Canton Police Station Reno  
 Project No.: 2023-001-01  
 Issue to: Bidders

Town of Canton, Owner  
 Contract Document Date: July 07, 2025  
 Addendum Date: March 31, 2026

**FINISH PLANS**

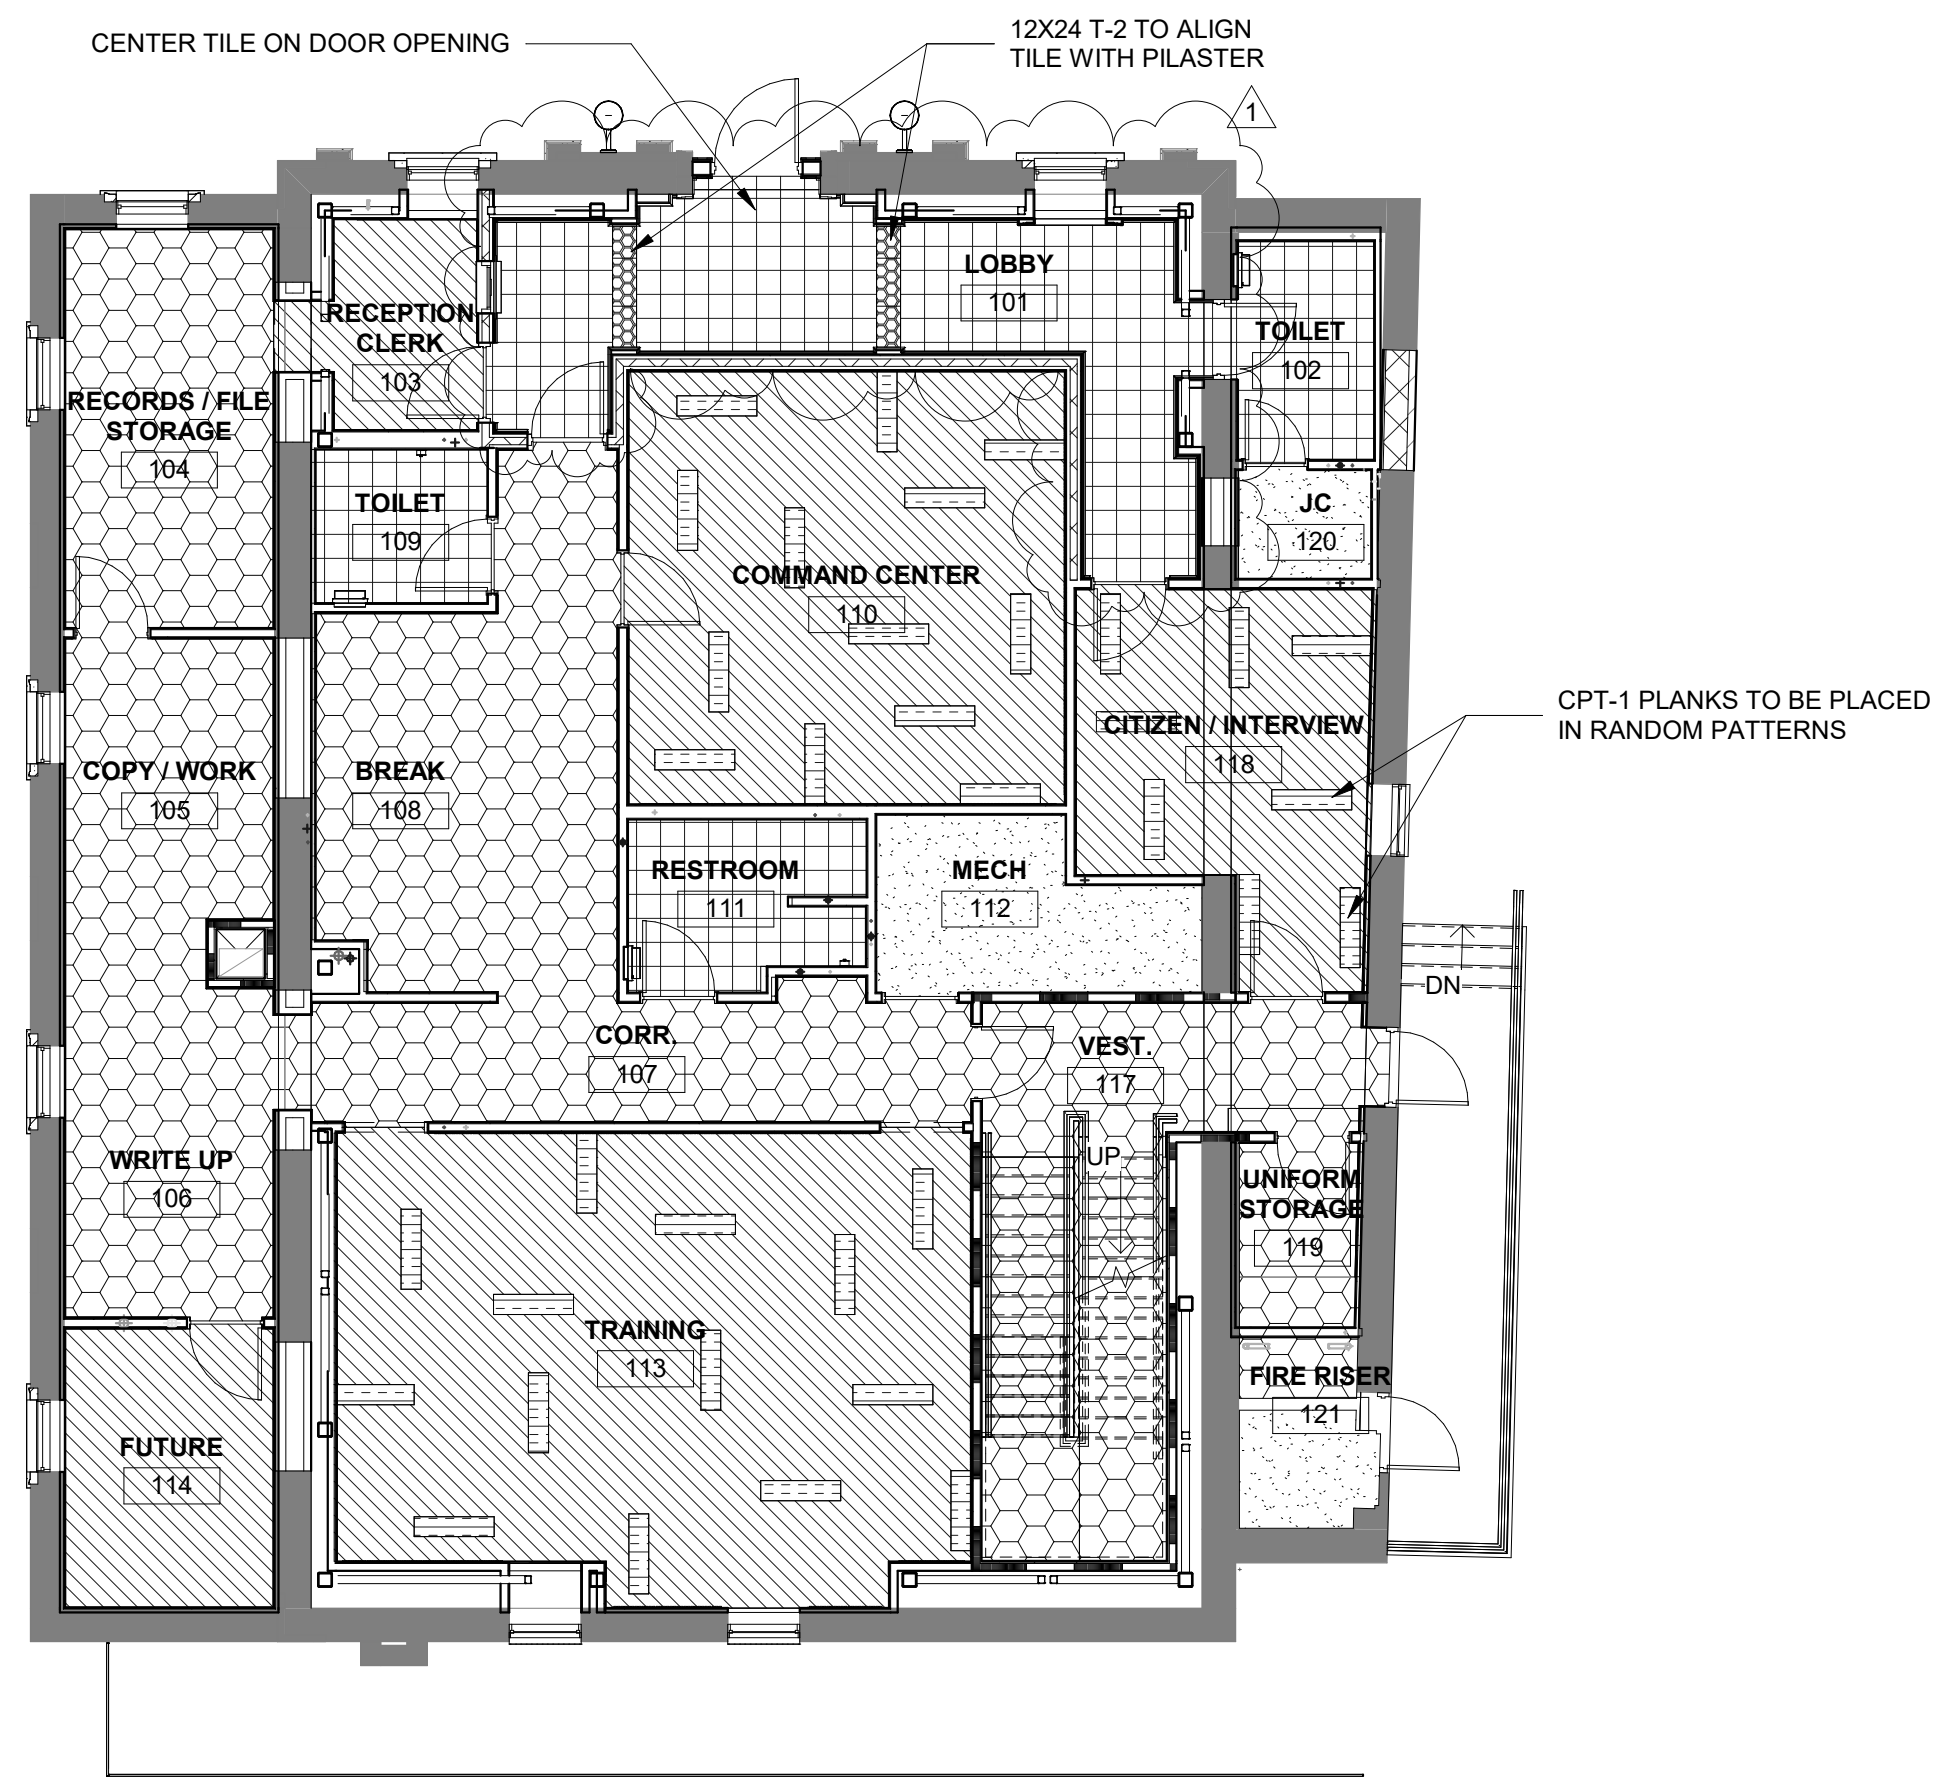
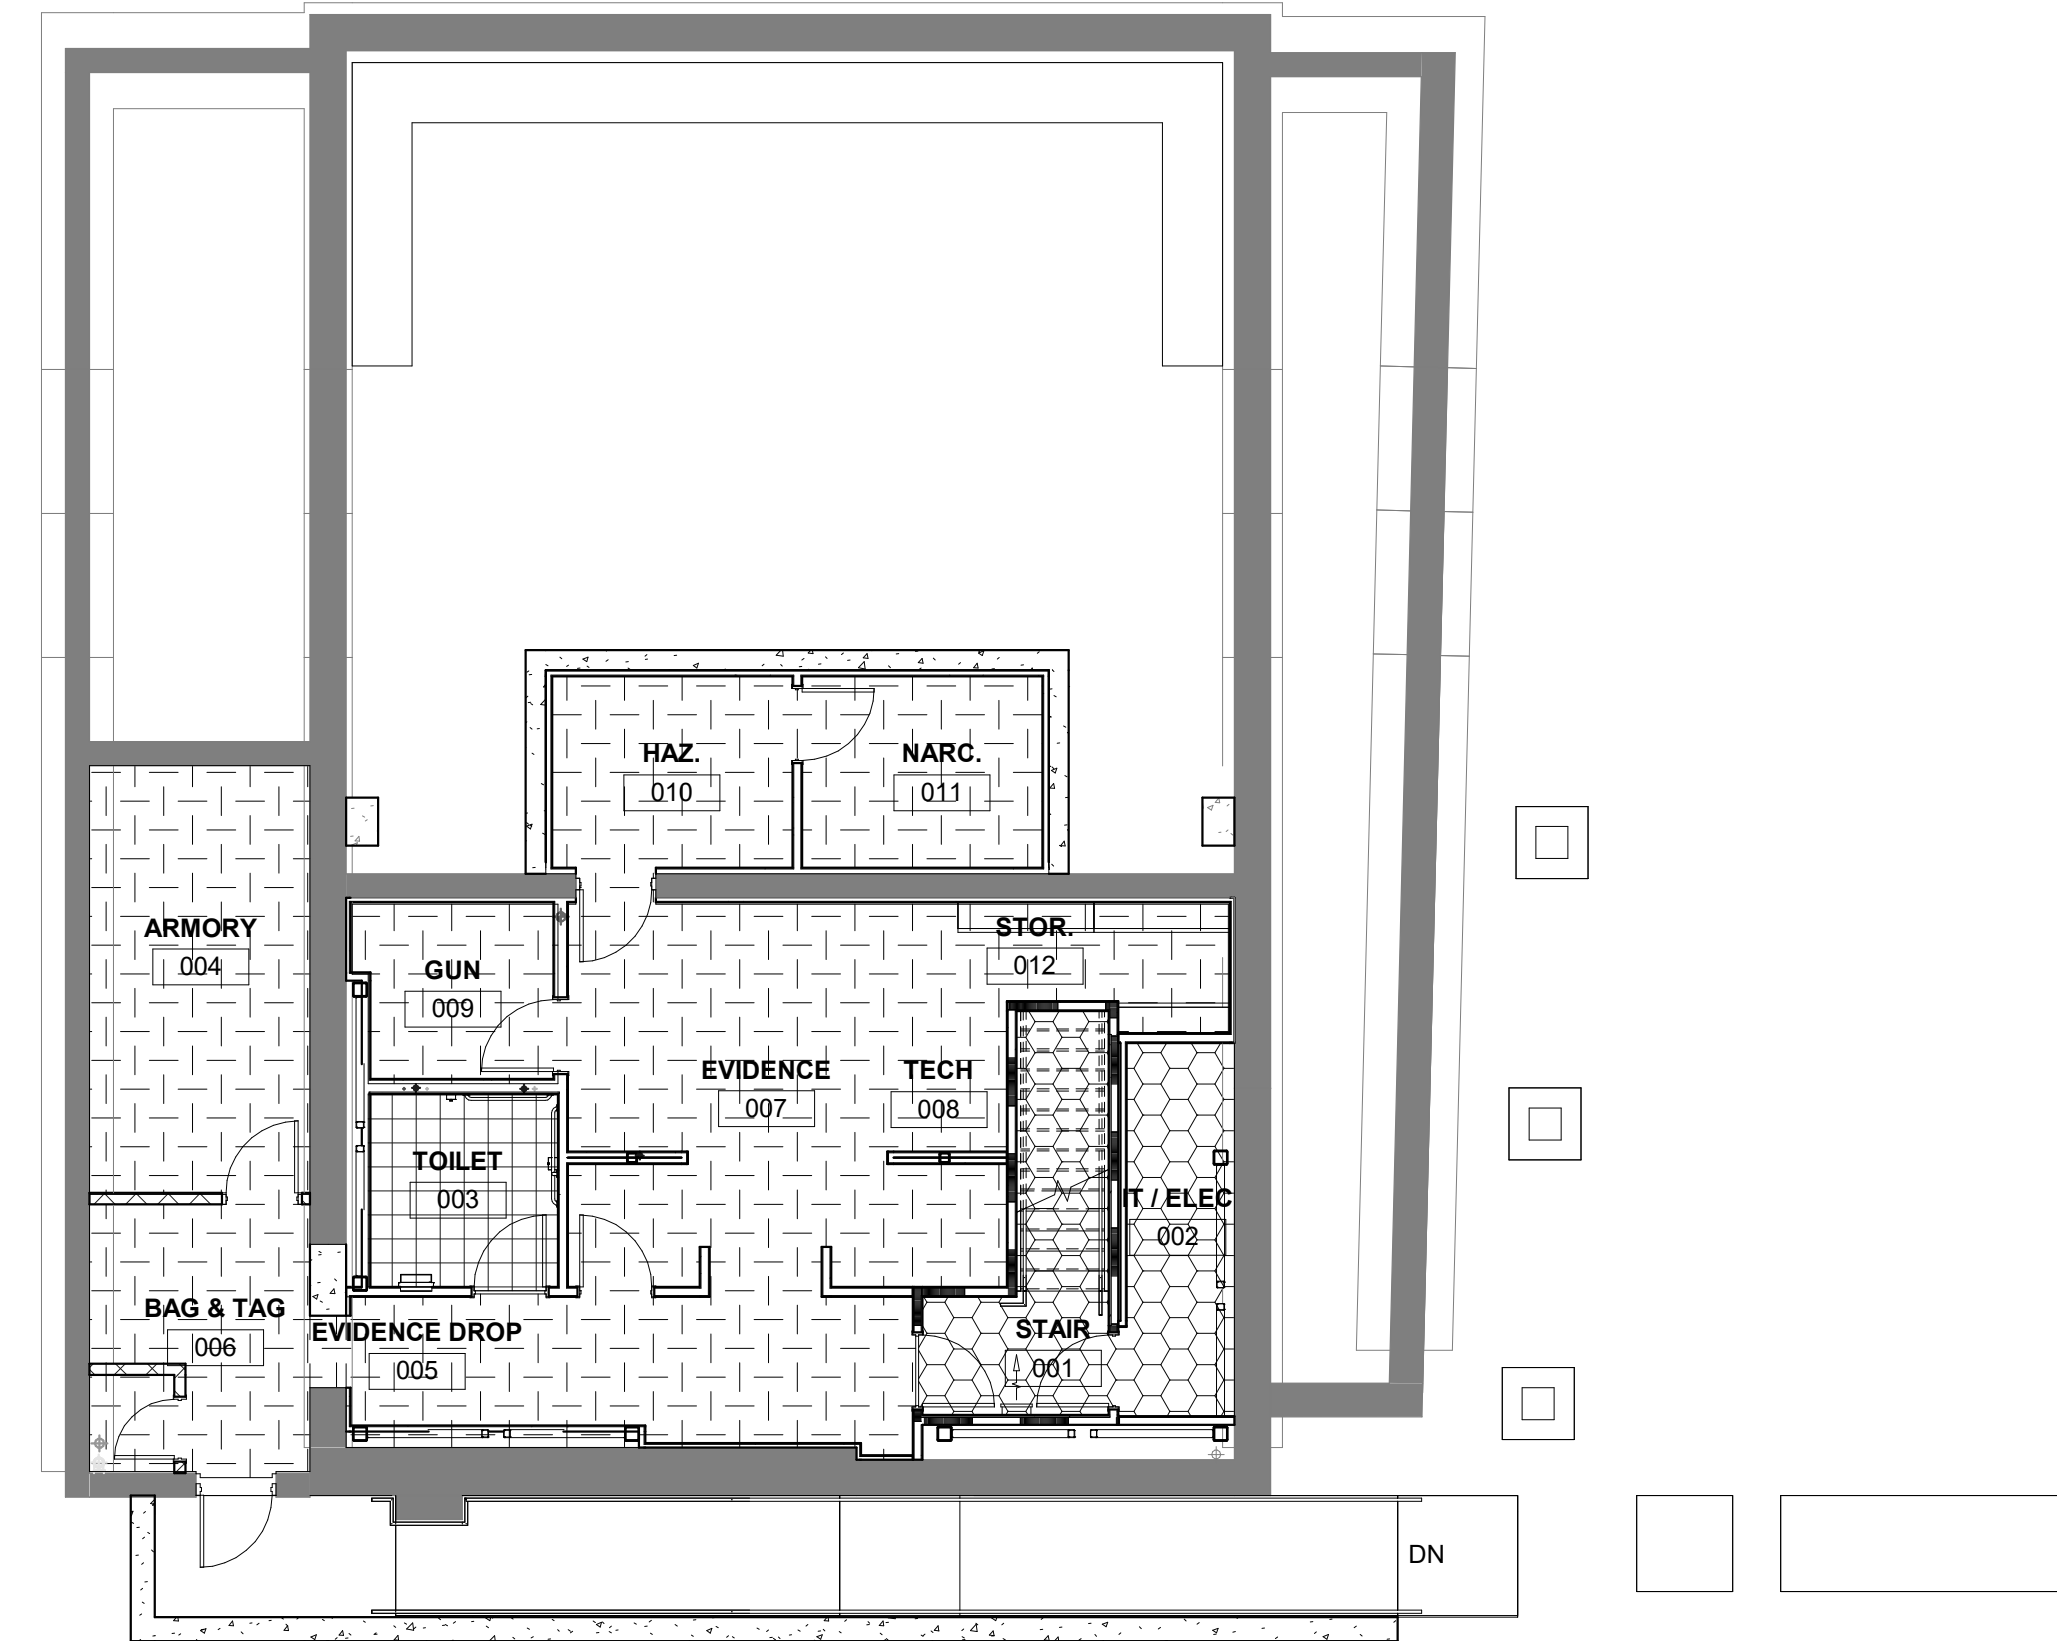
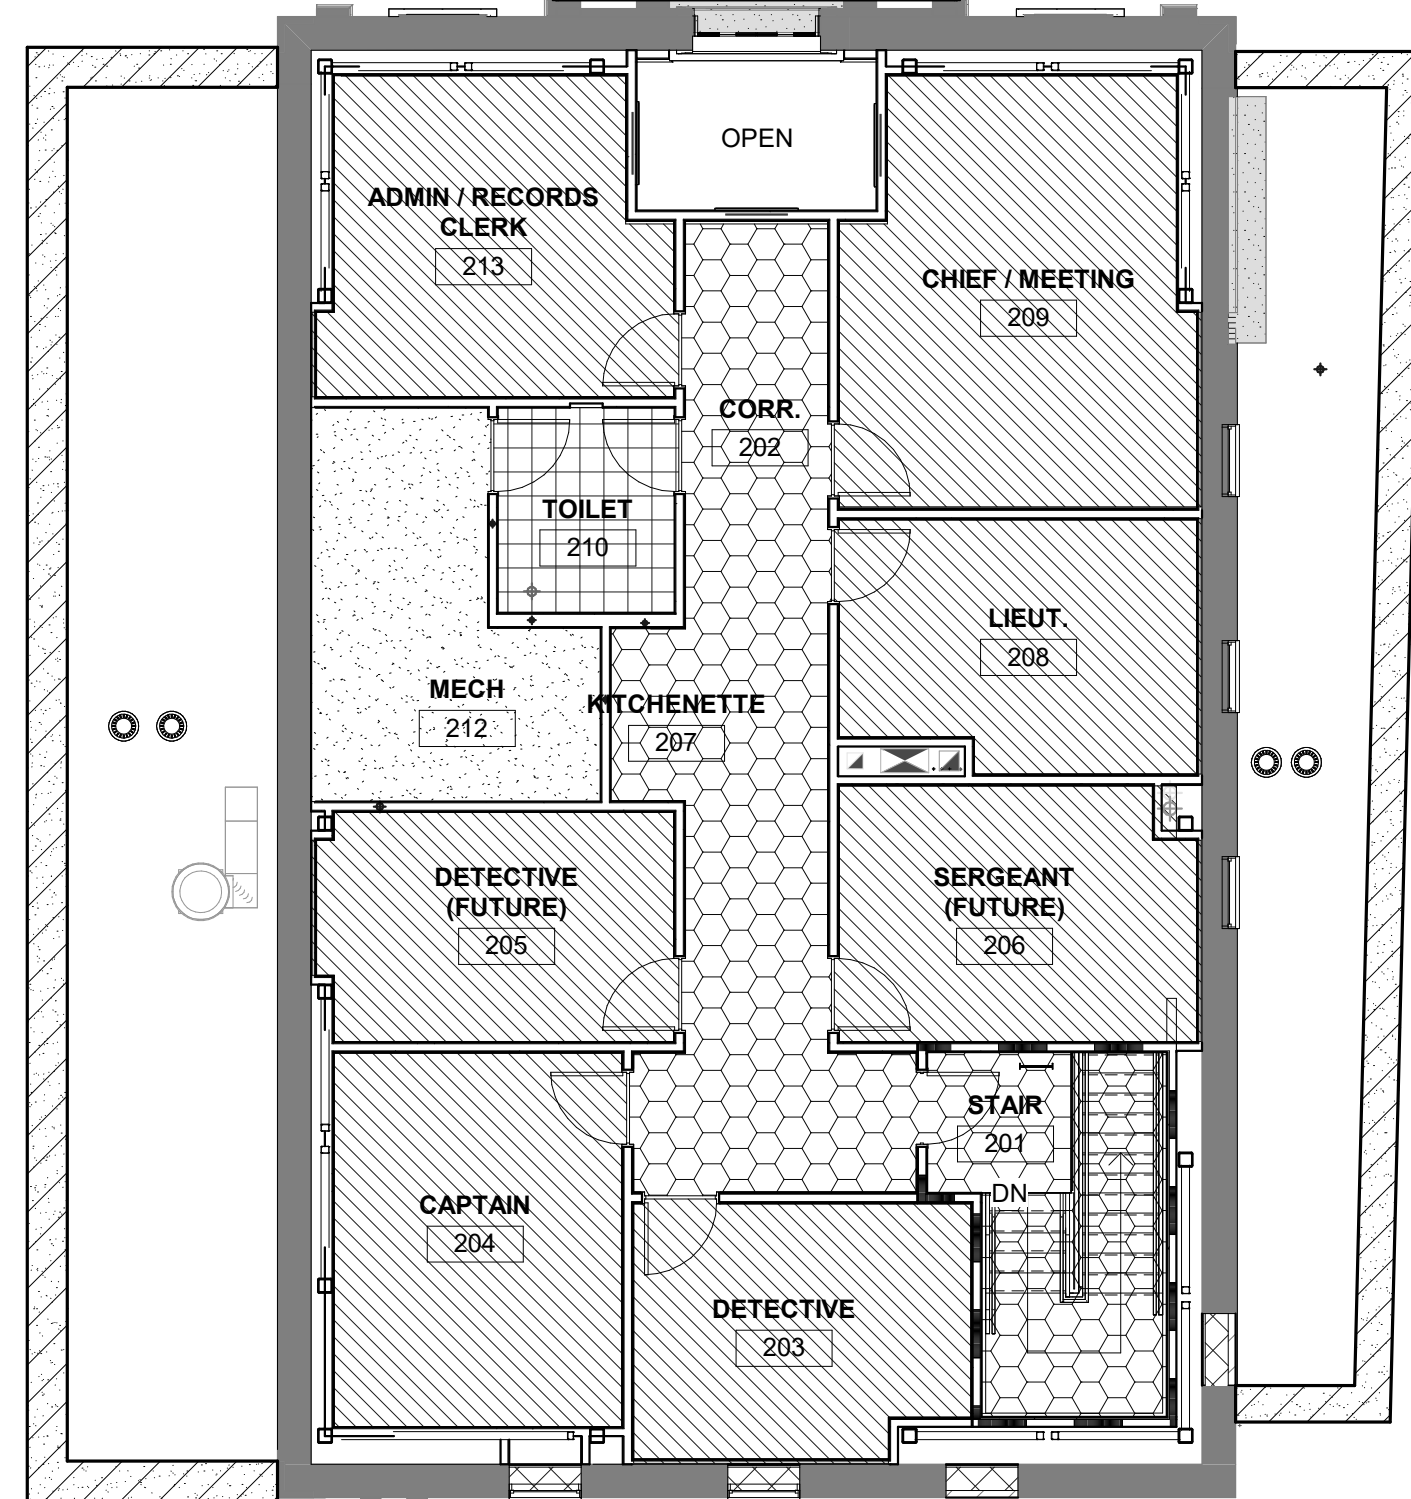
- e) T-5: Please confirm if Matte is the desired finish as K189 is gloss, The matte would be K-789.
- 1) Use K-789. Drawings revised.
- f) The T-1 and T-2 tiles are shown with two T-1 12"x12" tiles aligning with the 24" side of the T-2 tiles. The two 12"x12" tile without a grout line will overhang the 24" side by 3/16". Please advise if there will be a design change.

- 1) Sheet A10.21 has been revised to separate the grout lines to avoid this issue. Also, T-2 has been removed in the main field of tile and only occurs at the pilaster threshold.
